PROJECT: North Castle NY - JG Petrucci DATE: 7/12/2021
 2179-99-009
 SUBJECT: 94 Business Park Drive TRANSMITTAL ID: 00006
 PURPOSE: For your use VIA: Info Exchange

**RE: Armonk Fairview, LLC &
Aggro and Brassi, LLC
Proposed Warehouse
Section 108.03; Block 1; Lot 50
94 Business Park Drive
Town of North Castle (Armonk)
Westchester County, NY
DEC #2179-99-009**

The following are responses to an engineering review letter prepared by Kellard Sessions dated March 5, 2021:

TITLE: **STORM AND SANITARY PROFILE**

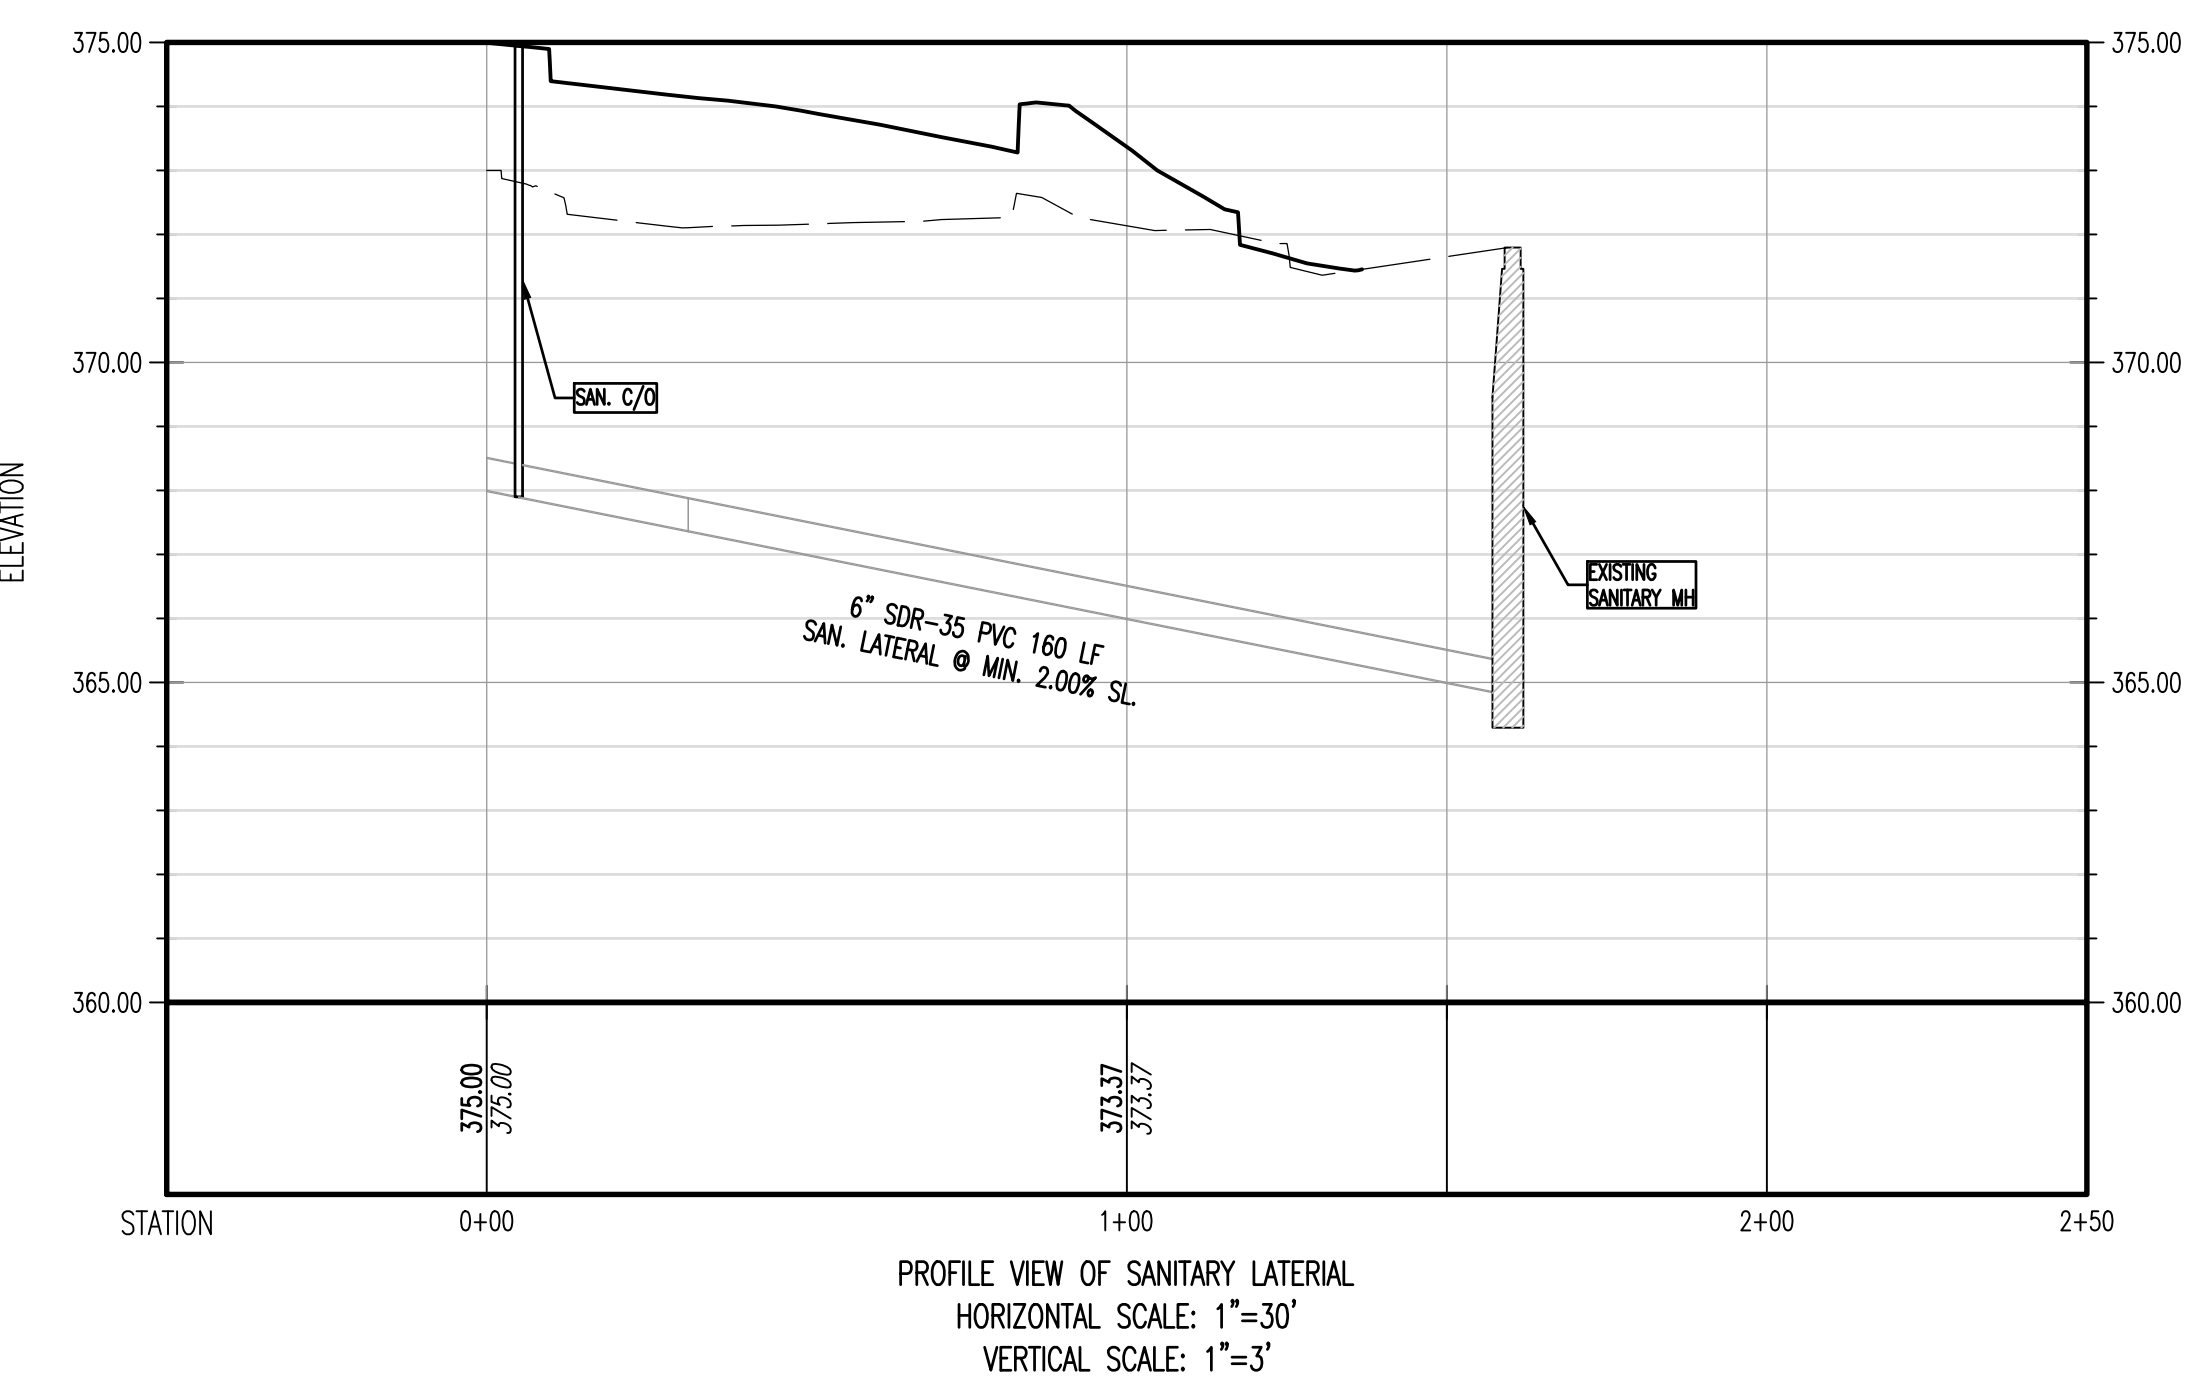
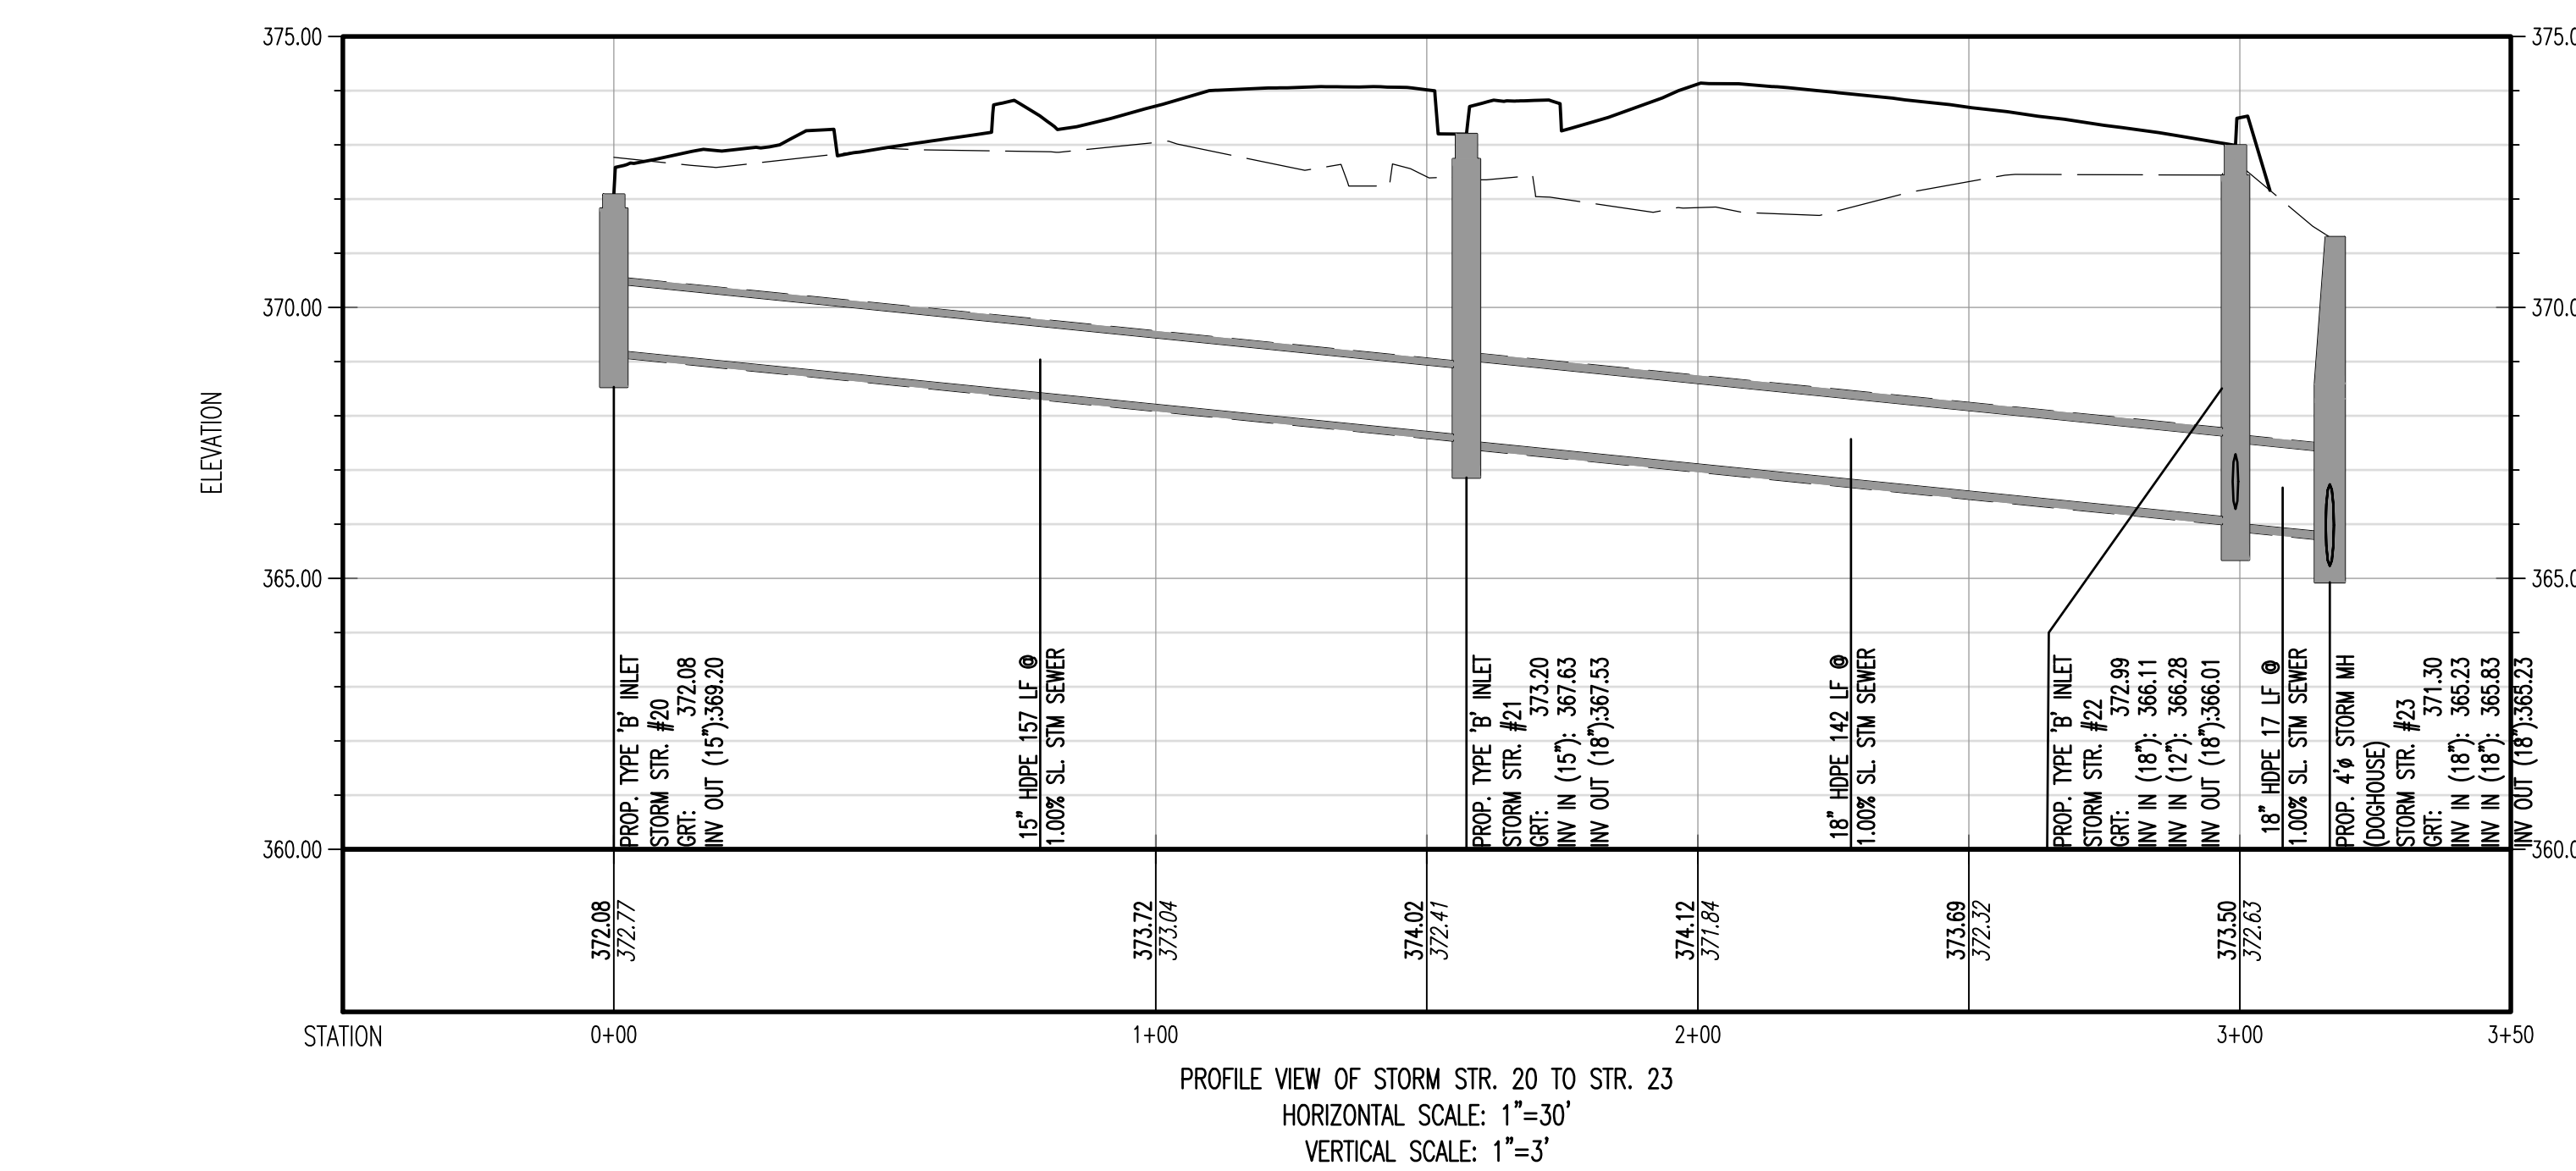
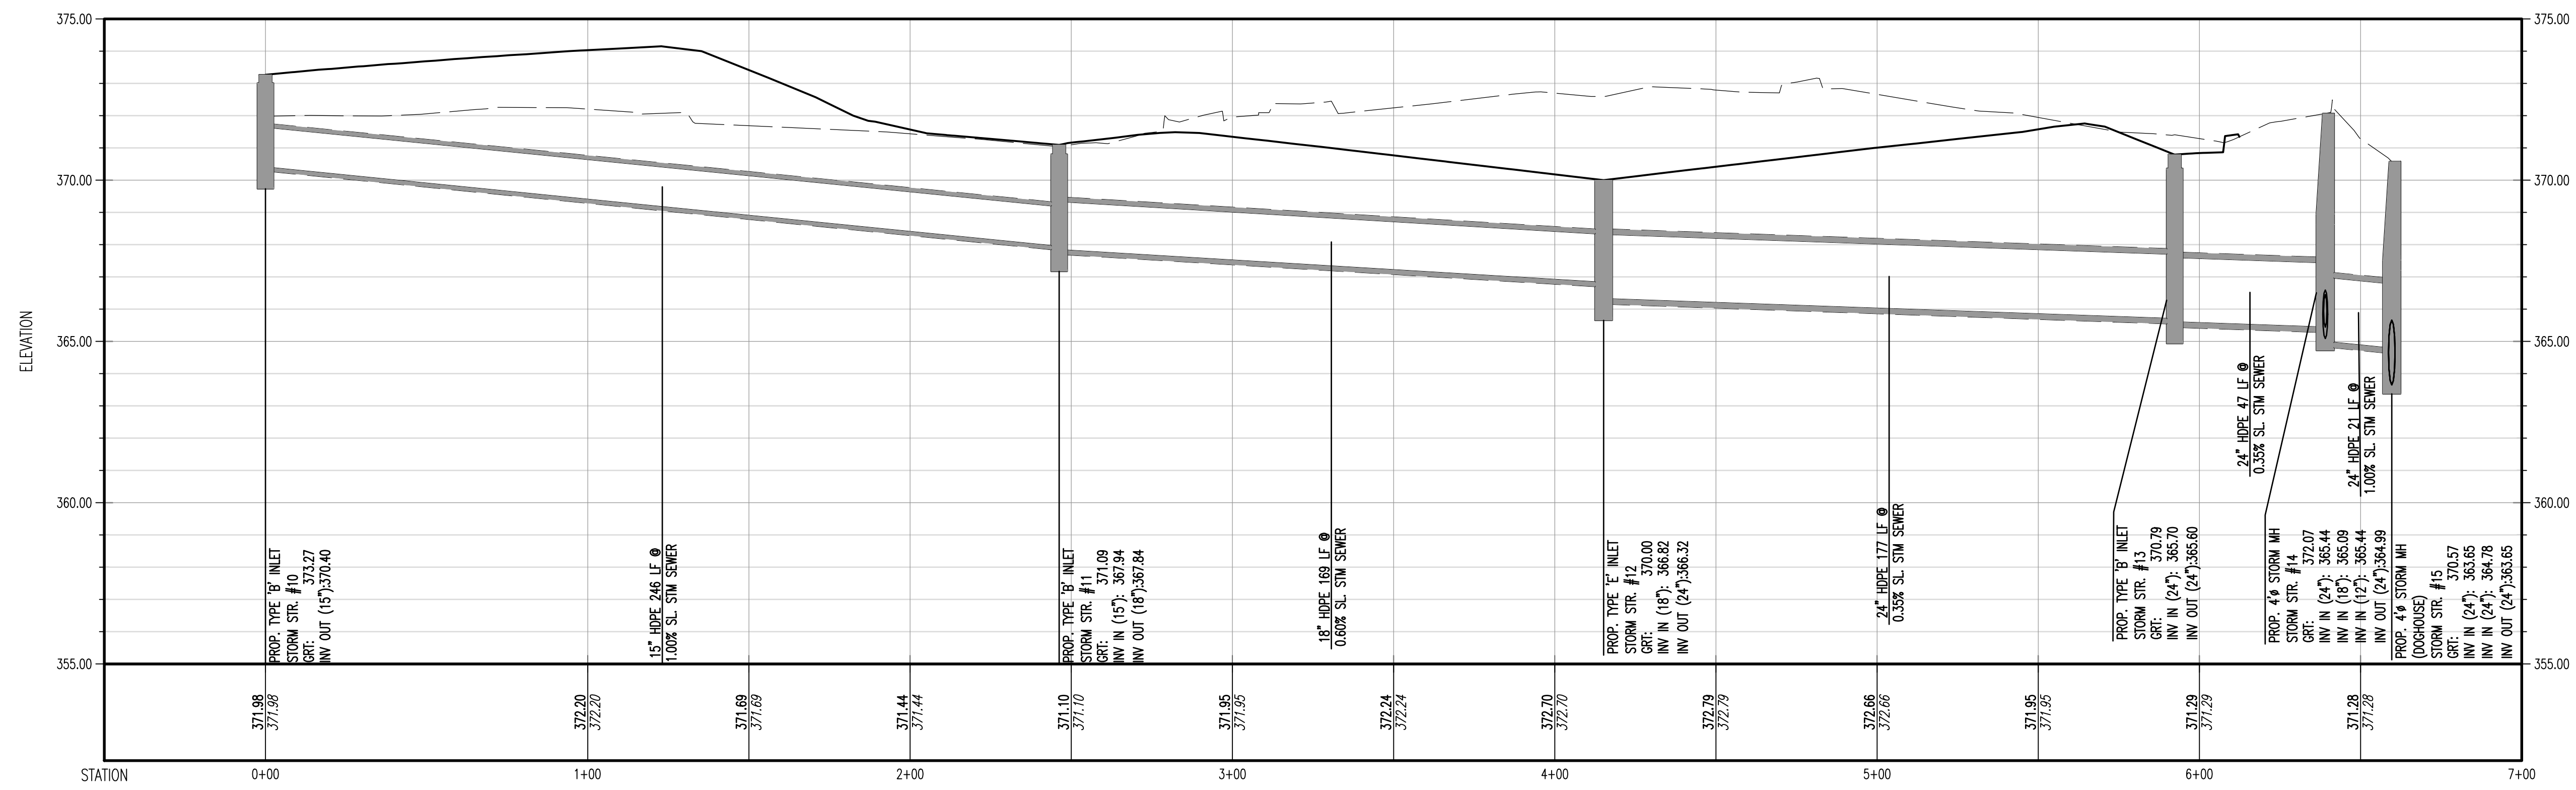
15. The plan should include profiles for all drainage conveyances to demonstrate adequate cover and slope and that there are no conflicts with other utilities.

The plan has been revised to include profiles.
